From: jjm66@aol.com
Sent: Thursday, May 18, 2023 4:58 PM
To: Don Scott
Subject: Public Comment Lee MPO May 19th, 2023 Fwd: Public Comment 3-27-2023 BPCC fpn 429823 and fpn 435341

From: jjm66@aol.com
To: dscott@leempo.com <dscott@leempo.com>; rgogoi@leempo.com <rgogoi@leempo.com>; derek.rooney@gray-robinson.com <derek.rooney@gray-robinson.com>; jennifer.marshall@dot.state.fl.us <jennifer.marshall@dot.state.fl.us>; john.crocker@dot.gov <john.crocker@dot.gov>; carlos.a.gonzalez@dot.gov <carlos.a.gonzalez@dot.gov>; james.christian@dot.gov <james.christian@dot.gov>; chuck.ward@oig.dot.gov <chuck.ward@oig.dot.gov>; scott.v.harding@oig.dot.gov <scott.v.harding@oig.dot.gov>; kimberly.likens@dot.state.fl.us <kimberly.likens@dot.state.fl.us>
Sent: Mon, Mar 27, 2023 4:59 pm
Subject: Public Comment 3-27-2023 BPCC fpn 429823 and fpn 435341

The image of the statewide SUN Trail (fpn 429823-1) is at a school crossing.

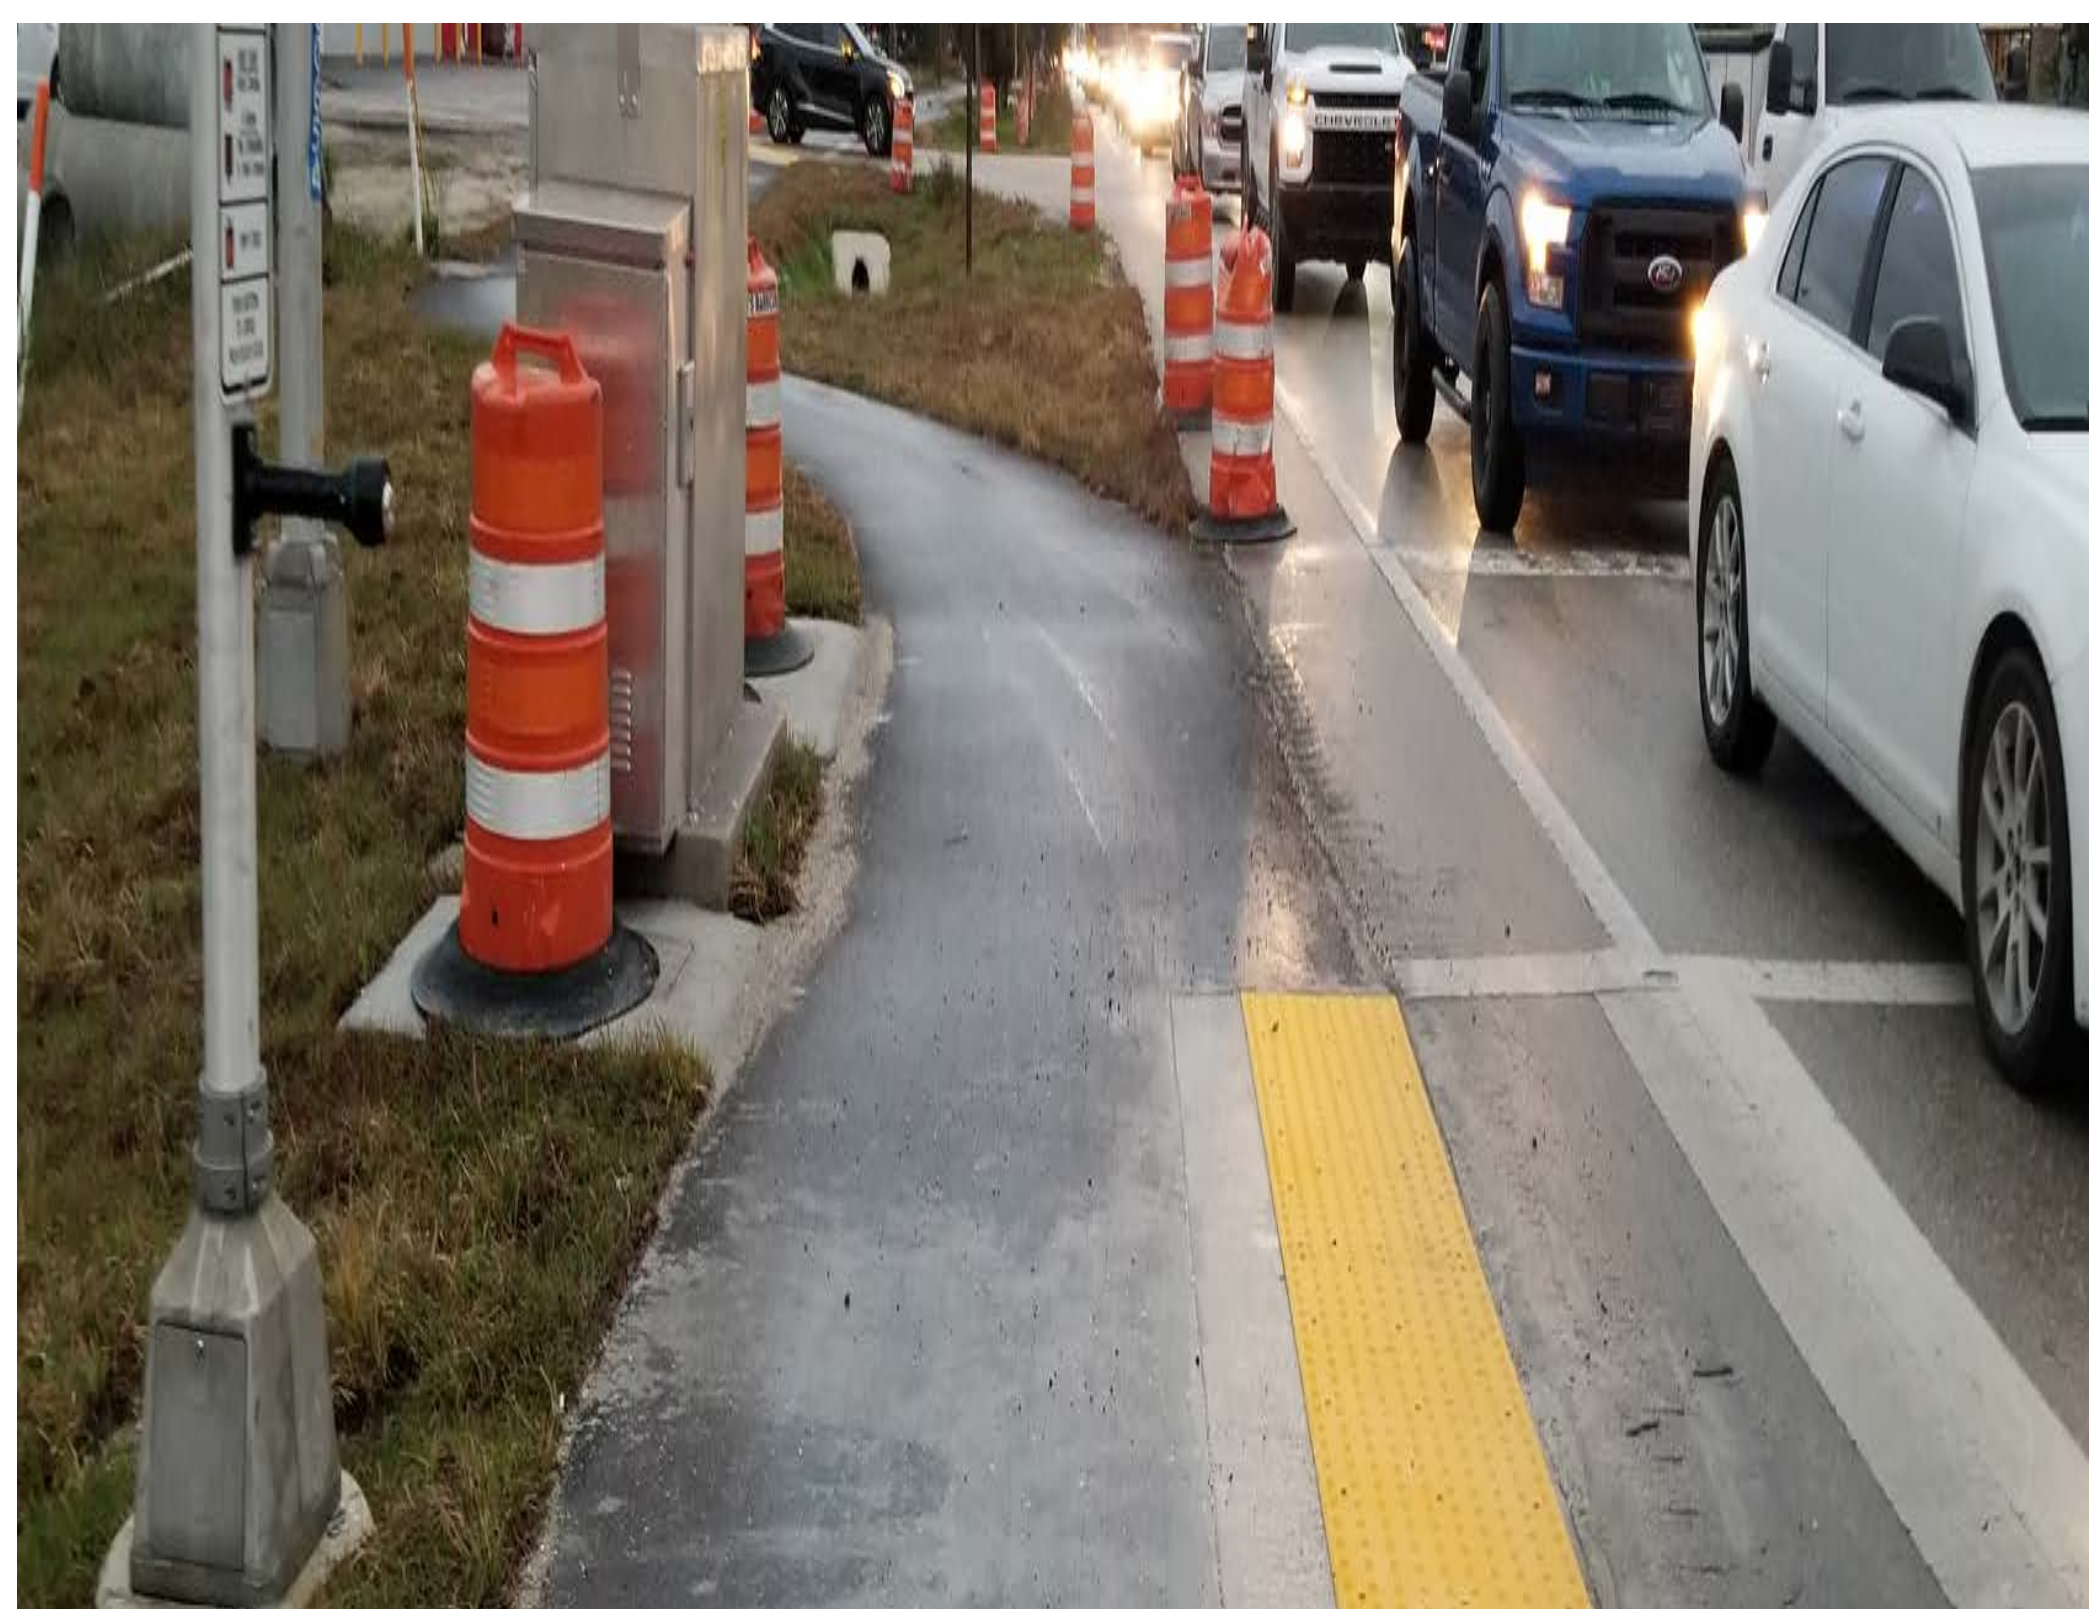
During construction there was a concrete curb constructed to protect the construction workers, but now the health safety and welfare of the children is in jeopardy. What were you thinking to influence the advisory committees and MPO board to vote for this project?

I offered to fund a concrete box culvert so the alignment of this section of the Statewide SUN Trail Network (Image 1) could be shifted away from the roadway so children waiting at the school crossing would not be forced to compete with cyclists and pedestrians all within a non-conforming 8' wide section of the SUN Trail abutting SR 80.
